BROWNS FERRY NUCLEAR PLANT (BFN) - UNIT 1 - TECHNICAL SPECIFICATIONS (TS) CHANGE 437 - RESPONSE TO REQUEST FOR ADDITIONAL INFORMATION REGARDING SCRAM DISCHARGE VOLUME WATER LEVEL SETPOINT (TAC NOS. MC1427)

ENCLOSURE 1
TECHNICAL SPECIFICATION 437
SCRAM DISCHARGE VOLUME WATER LEVEL SETPOINT
RESPONSE TO NRC REQUEST FOR ADDITIONAL INFORMATION

SCRAM DISCHARGE INSTRUMENT VOLUME

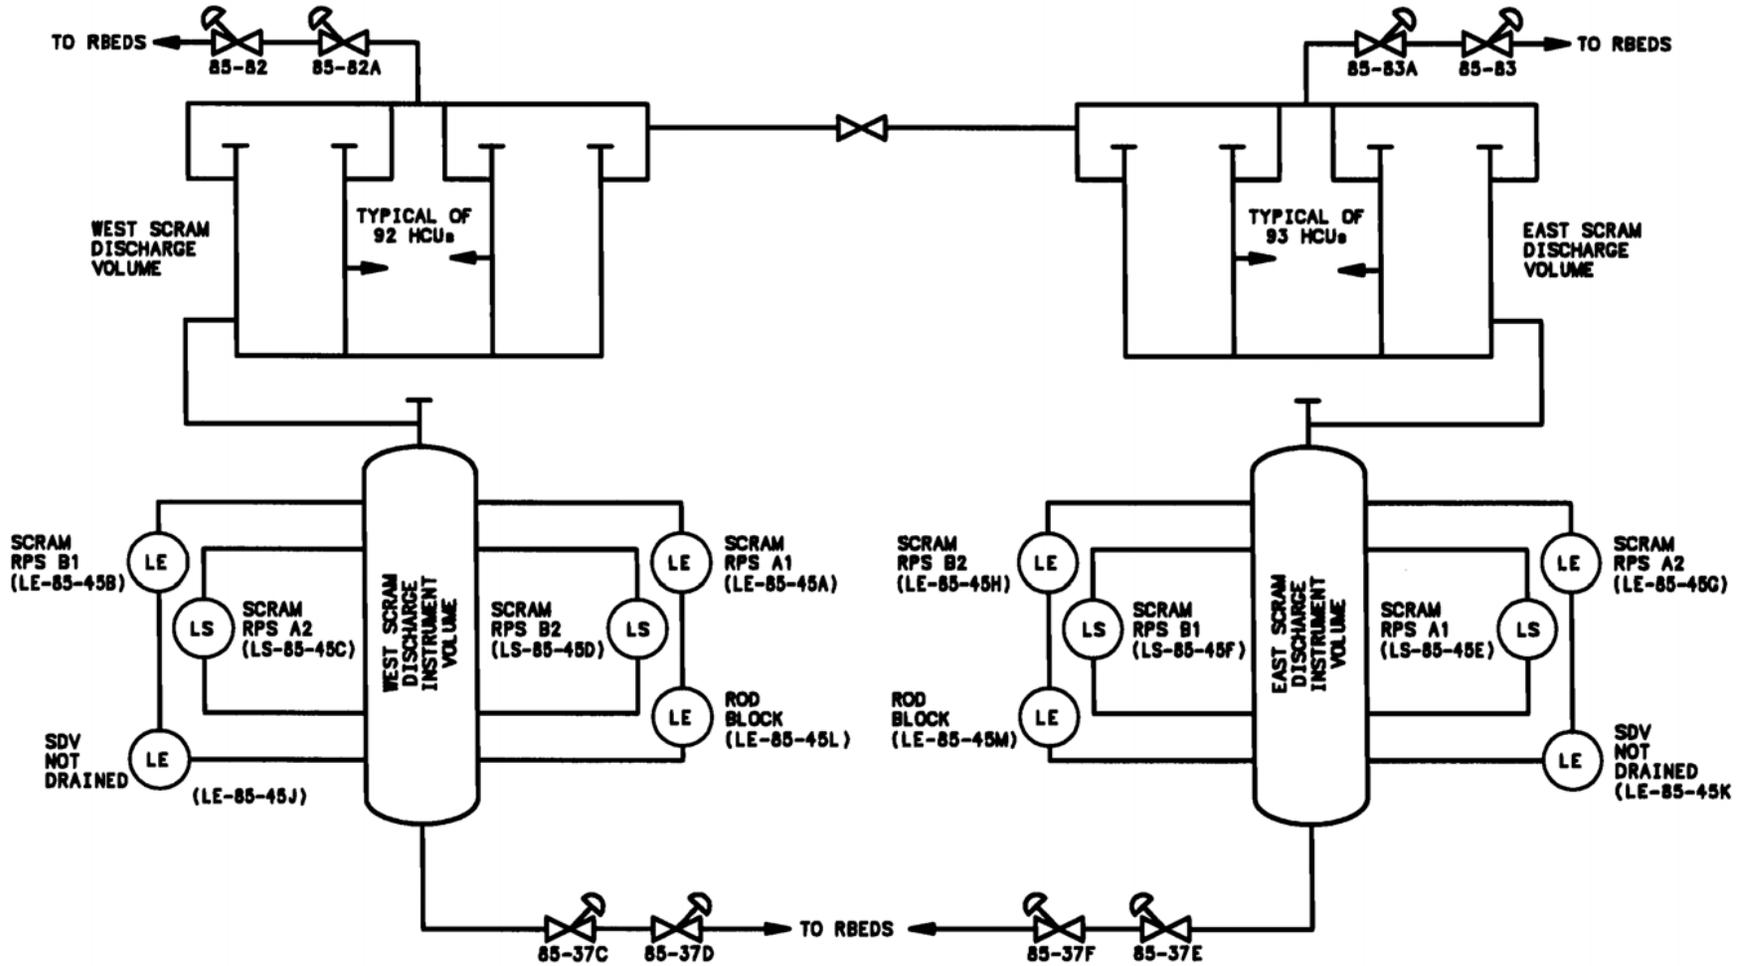
- (2) Please provide simplified drawings showing the configuration of the scram discharge volume, the instrument volume, and the location of all level switches.

The requested sketch is provided on the next page.
